Consent Commission – Commissioner

- 2.1 Hearing Report for CBH Limited Applications RM130922 (Subdivision to create 20 additional allotments) and RM130923 (Land Use - To erect a dwelling on each of the proposed additional allotments) 7

2.1 HEARING REPORT FOR CBH LIMITED APPLICATIONS RM130922 (SUBDIVISION TO CREATE 20 ADDITIONAL ALLOTMENTS) AND RM130923 (LAND USE - TO ERECT A DWELLING ON EACH OF THE PROPOSED ADDITIONAL ALLOTMENTS)

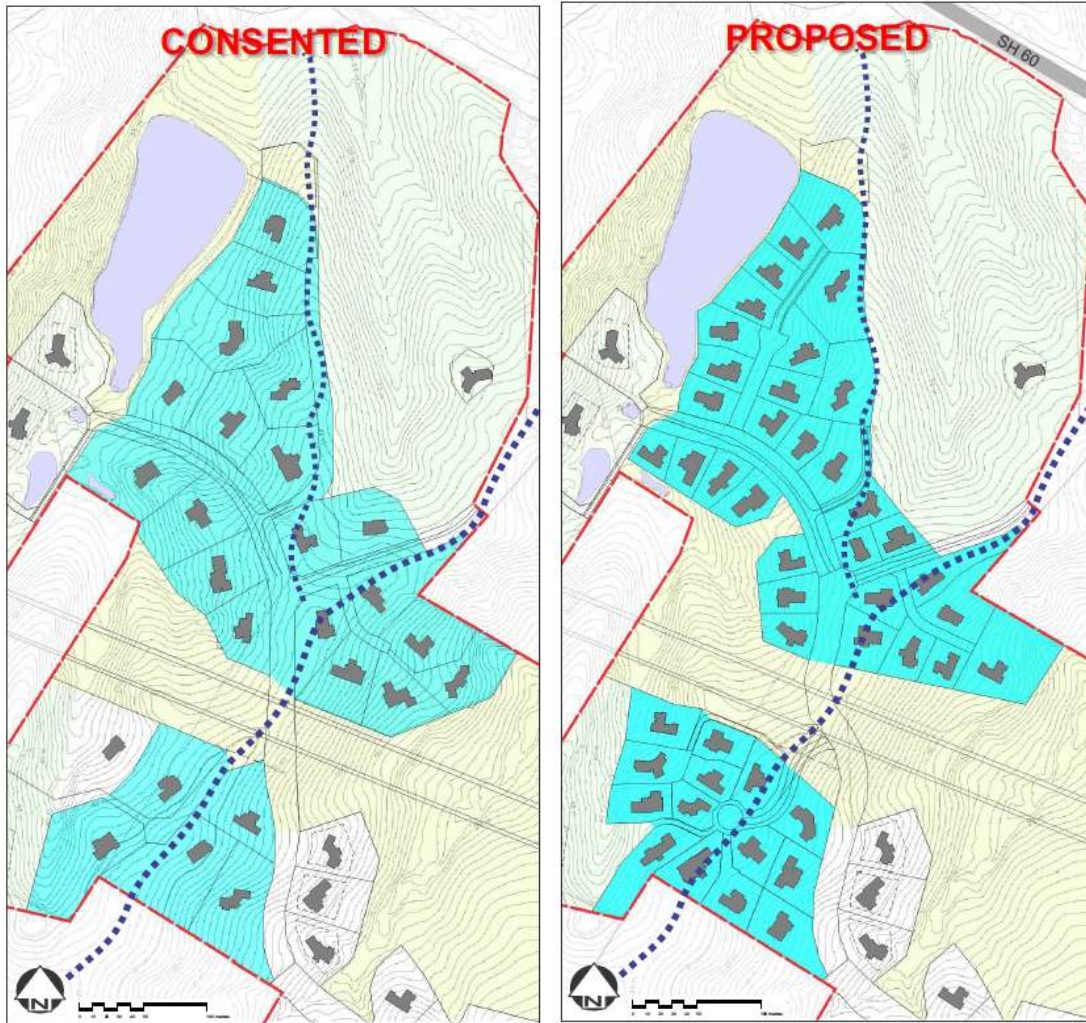
- 1.1 The diagrams below represent the **consented** subdivision RM100632 and this **proposed** subdivision (RM130922) currently being assessed. The proposal shows an overall increase of twenty additional allotments within the same footprint. If anything there is a small decrease in the area of land utilised for allotments and an increase of the allotment boundary setbacks from Transmission lines. This application puts forward a new layout and density of allotment design for the remaining balance area of Appleby Hills Rural 3 development encompassed within CFR 544040. The density change is significant shift from the consented subdivisions of RM030632 and RM100632. RM100632 created new allotments but it retained a similar density of allotments within clusters that provided amenity and landscape values consistent with the original consent.

Table1 below (next page) sets out the range of proposed allotment sizes as the allotment dimensions are hard to read on the scheme plan. The range of sizes for allotments is smaller the approved areas within RM100632 where the smallest area is 2540m².

As a planner weighing up all of the relevant considerations in terms of Section 5 of the Act, I consider that a grant of consent **would not** promote the sustainable management of natural and physical resources and, on balance, I strongly **RECOMMEND** that the application(s) be **DECLINED**.
